Wisconsin Department of Transportation

Proposal #15: 4200-05-71, WISC 2018 090
T Sheboygan Falls, Meadowlark Rd
Sheboygan River Bridge & Approaches
Local Str
Sheboygan County

This is Addendum No. 02, which provides for the following:

Addendum No. 02
 ID 4200-05-71
 Revised Sheet 51
 January 25, 2018

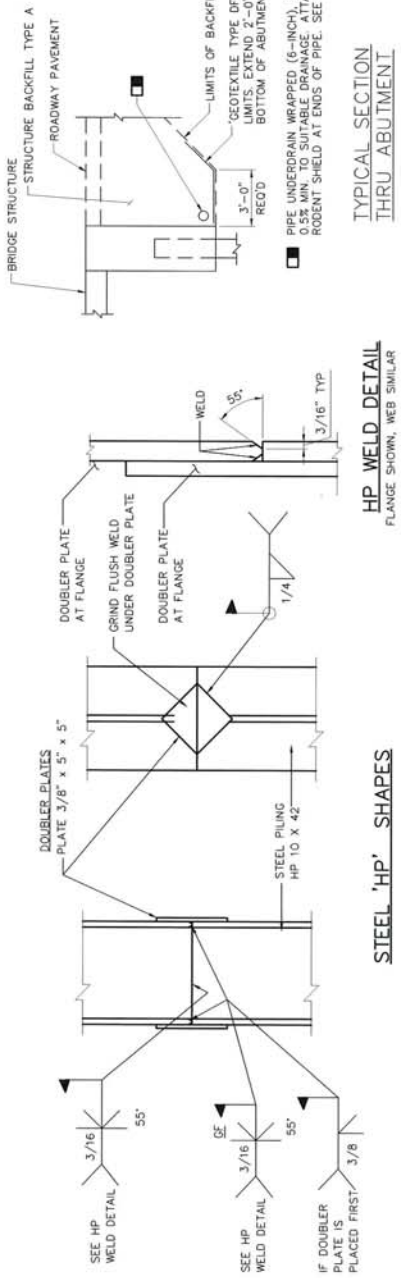
Revised Plan Sheets	
Plan Sheet	Plan Sheet Title (brief description of changes to sheet)
51	Changed center pier piling length to 288 LF and overall quantity to 832 LF
58	Changed piling depth from 27 LF to 32 LF in the "End View" note

513.4061	RAILING, TUBULAR TYPE, M B-59-194	LF	7	-	7	14
516.0500	RUBBERIZED MEMBRANE, WATERPROOFING	EACH	8	-	-	8
550.0500	PILE POINTS	LF	272	288	272	832
550.1100	PIILING STEEL HP 10-INCH X 42 LB	CY	46	-	-	46

Addendum No. 02
ID 4200-05-71
Revised Sheet 58
January 25, 2018

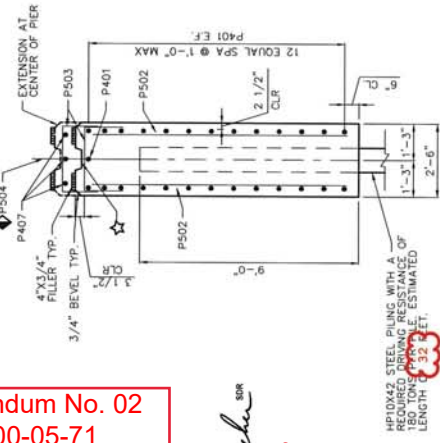
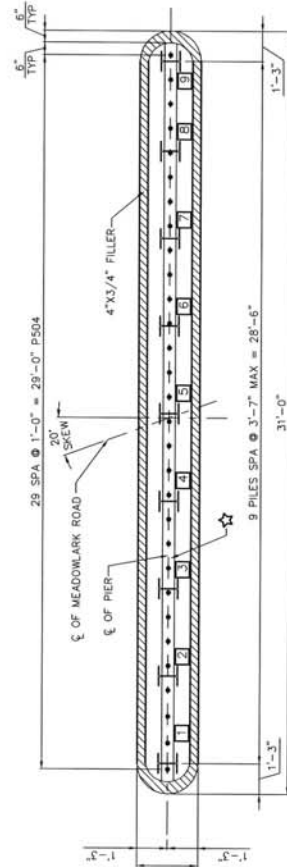
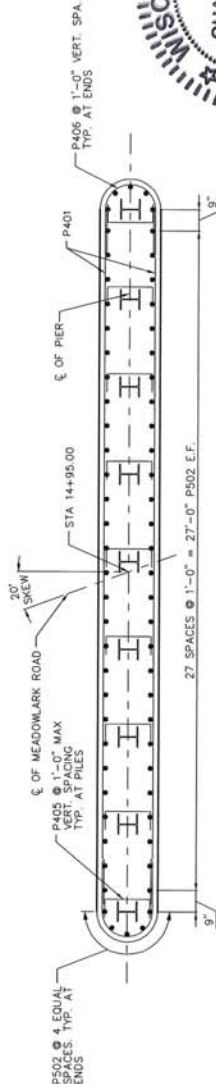
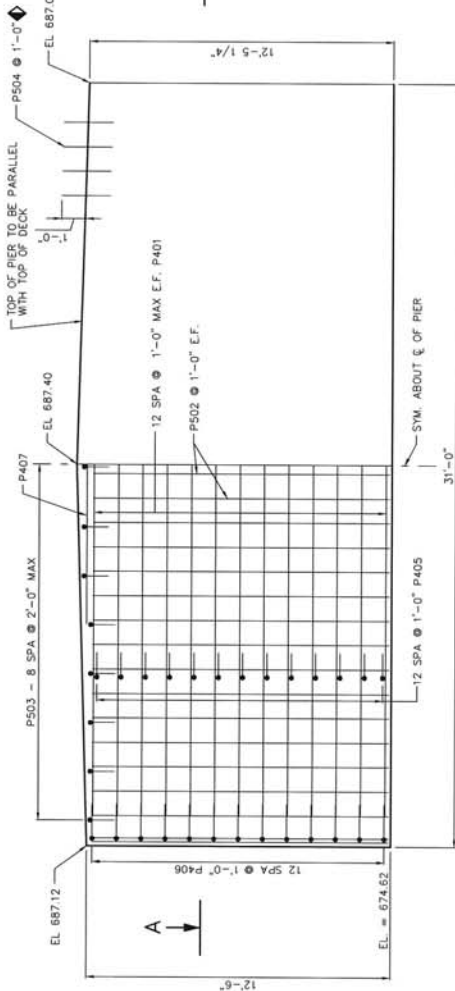
1. **NOTE CHANGE IN END VIEW SECTION**

HP10X42 STEEL PILING WITH A REQUIRED BENDING RESISTANCE OF LENGTH 432 FEET
